Former Morrisons Supermarket, Baldock Road, Royston - Materials

Olde Country Blend		Olde Sussex Blend

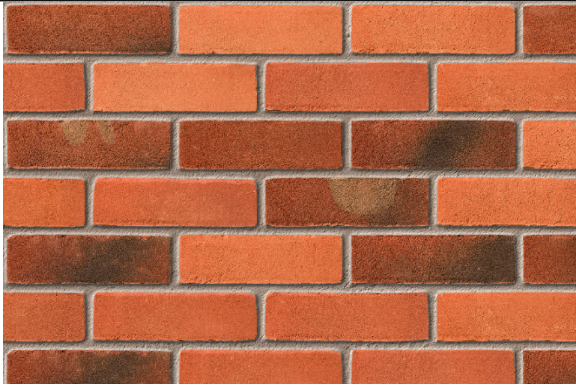
I note your comments on the bricks provided initially, please see below a selection of bricks that are available to us and would welcome your choice of any of these.
